DEVIATION REQUEST AND DECISION FORM

VR233

Project Name : Claremont Business Park 2 Filing No. 2

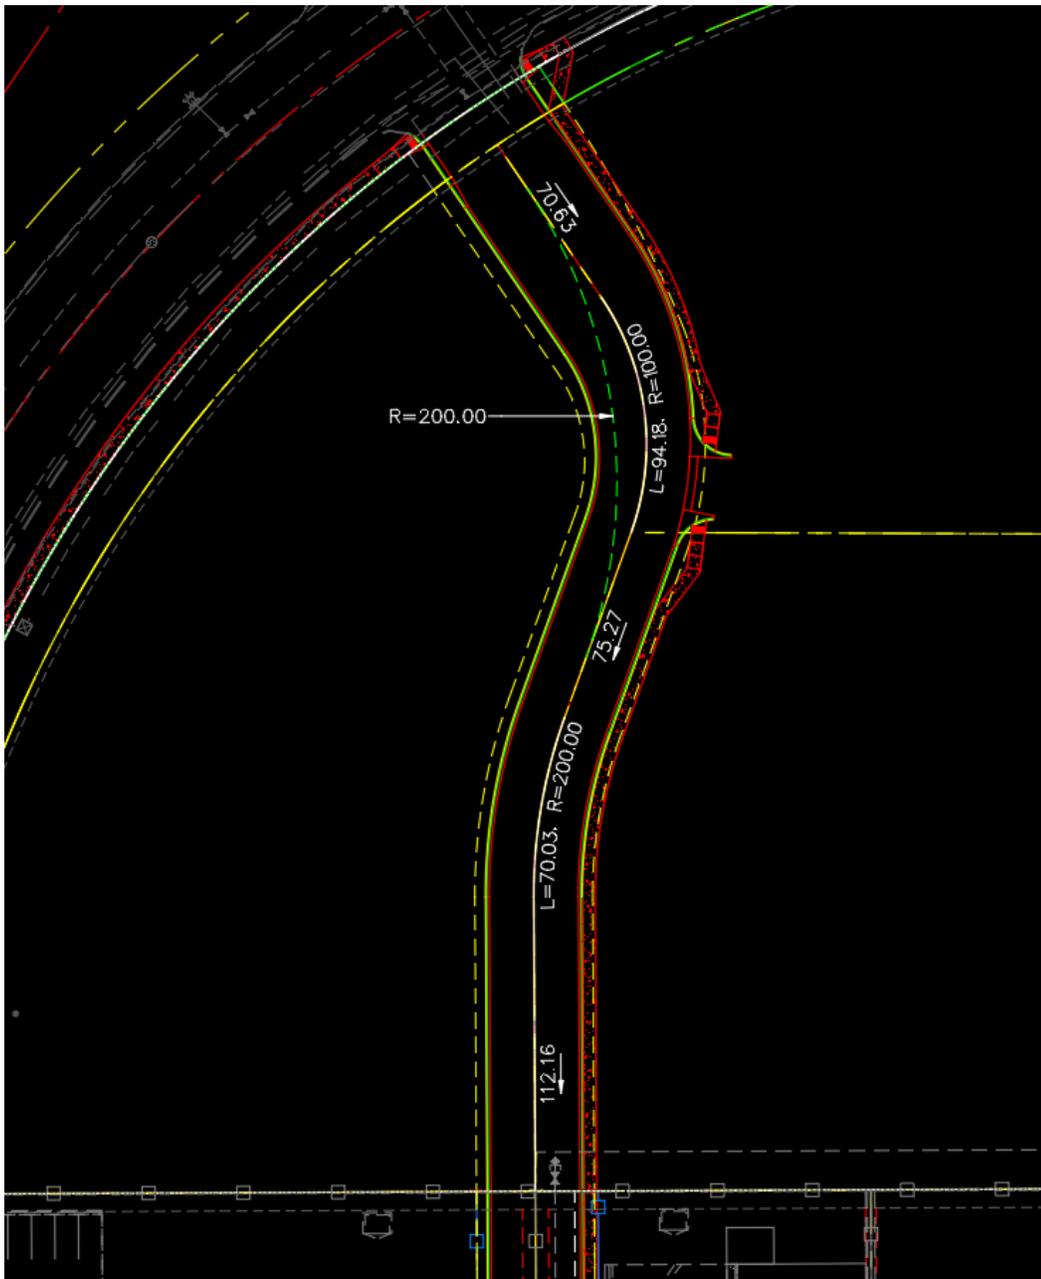
Please submit proof of the fire district's approval of the reduced radius and design.

- We request approval of a 100' minimum centerline radius, whereas the radius requirement is 200' at (1) one (north curve) curvilinear location within the El Jefe Heights roadway. Meeting the 200' radius requirement would inhibit adequate distance between the two proposed curves. See the image below of the proposal for the 100' vs. the 200' radius requirement.
